RS-06-116

September 26, 2006

Braidwood Station, Units 1 and 2
Facility Operating License Nos. NPF-72 and NPF-77
NRC Docket Nos. STN 50-456 and STN 50-457

Subject: License Amendment Request and Exemption Requests to Allow Use of AREVA NP Inc. Advanced Mark-BW(A) Fuel Assemblies

Figure 3.7.16-1 (page 1 of 1)
Region 2 All Cell Configuration Burnup Credit Requirements
(Joseph Oat Spent Fuel Pool Storage Racks)

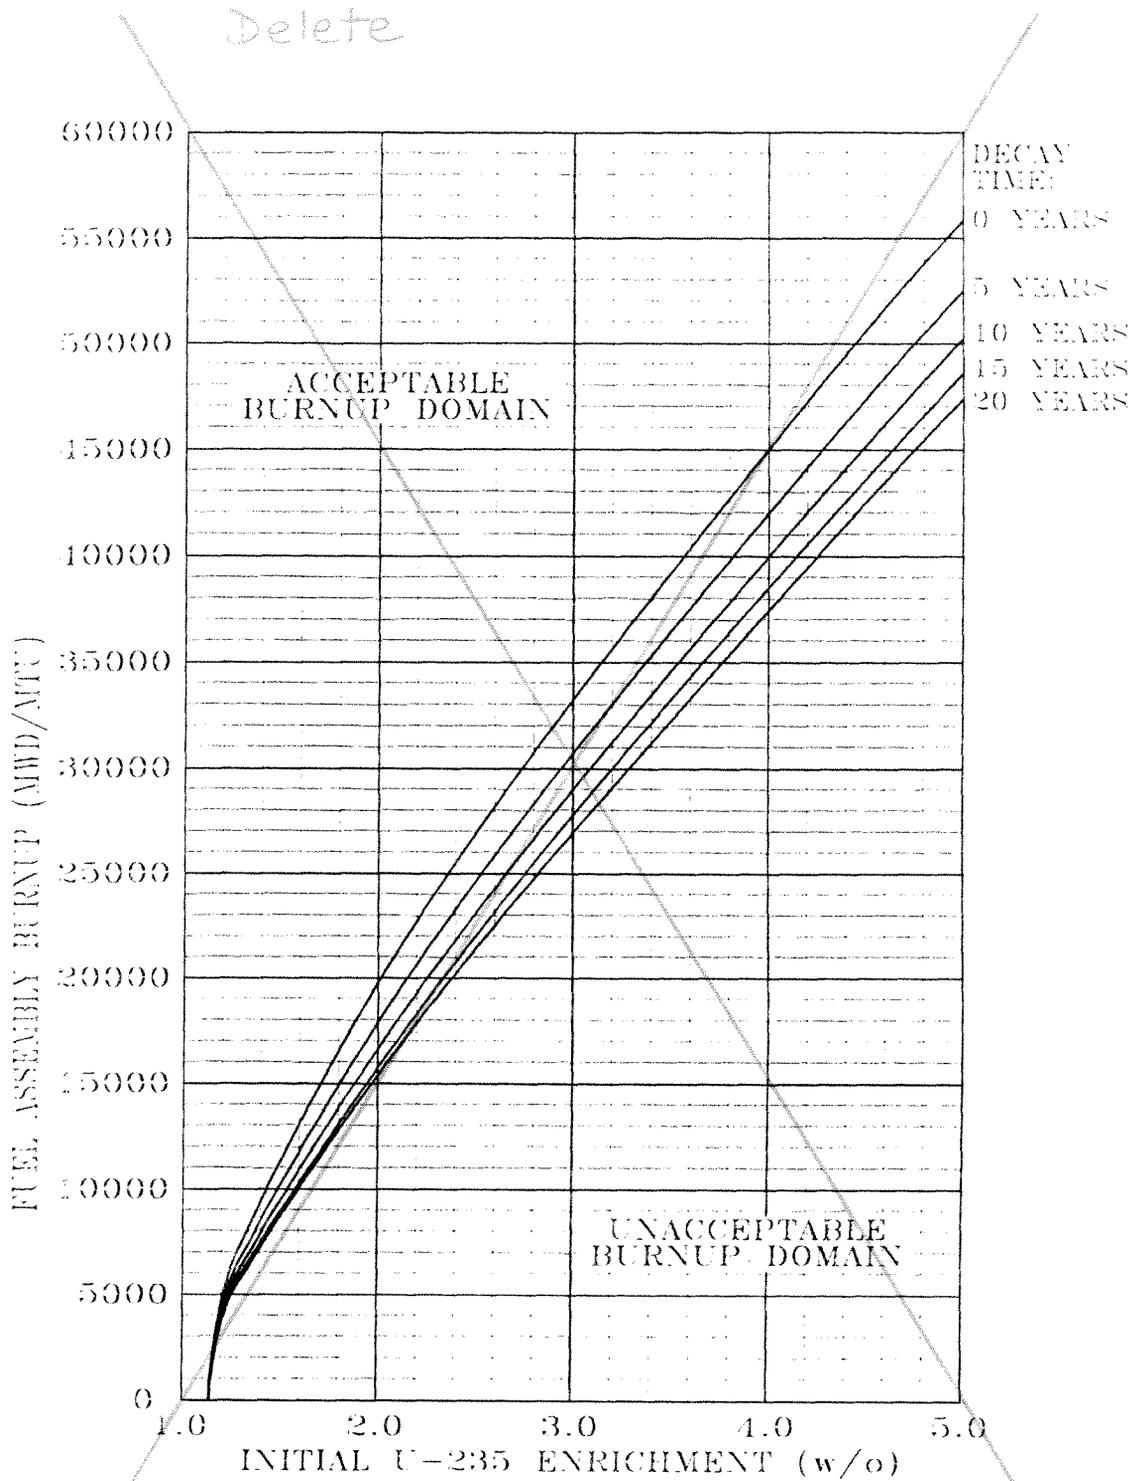
Surveillance Requirement (SR) 3.7.16.3, and existing Figures 3.7.16-1, 3.7.16-2, and 3.7.16-3 will be deleted in their entirety.

The proposed revisions to TS 3.7.15, TS 3.7.16 and TS 4.3.1 to remove all references to Joseph Oat spent fuel pool storage racks is editorial only and will delete wording that is no longer required. The revisions will result in various editorial and formatting change requirements and as a result of the proposed revision to TS 3.7.16, Surveillance Requirement (SR) 3.7.16.3, and existing Figures 3.7.16-1, 3.7.16-2, and 3.7.16-3 will be deleted in their entirety.

Delete

Figure 3.7.16-4 (page 1 of 1)
Region 2 Fuel Assembly Burnup Requirements
(Holtec Spent Fuel Pool Storage Racks)

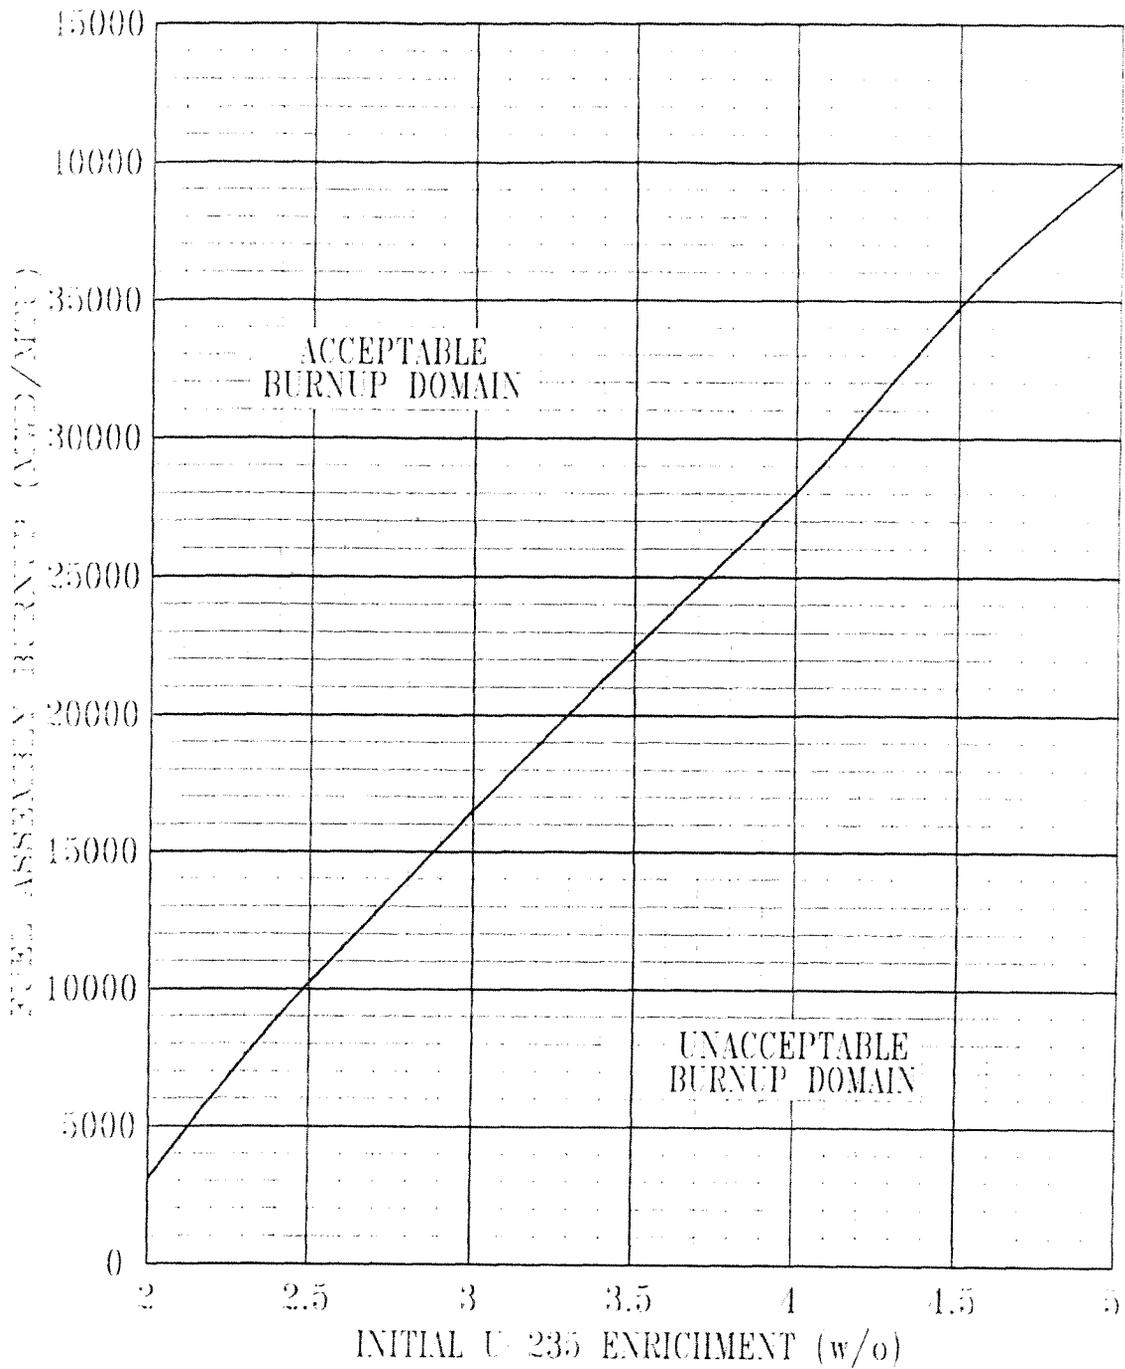
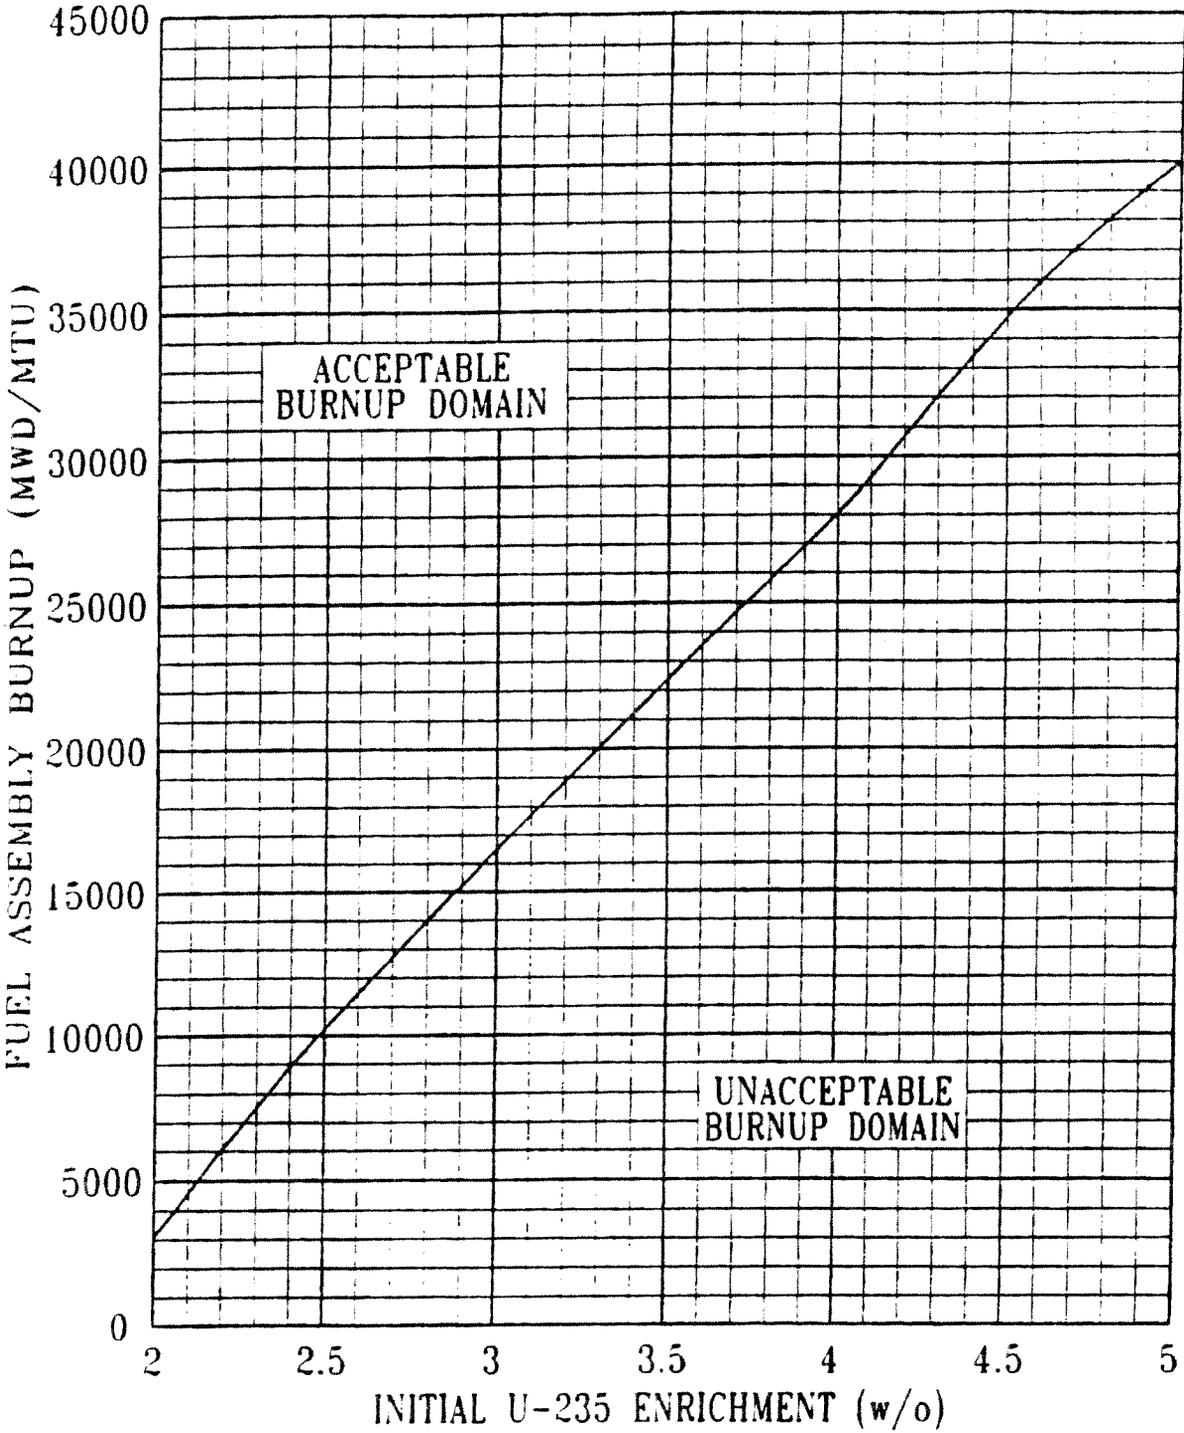
For the Holtec spent fuel pool storage racks, in LCO Figure 3.7.16-1, the Acceptable Burnup Domain lies on, above, and to the left of the line.

The use of linear interpolation between minimum burnups in Figure 3.7.16-1 is acceptable.

Figure 3.7.16-1 (page 1 of 1)
Region 2 Fuel Assembly Burnup Requirements
(Holtec Spent Fuel Pool Storage Racks)
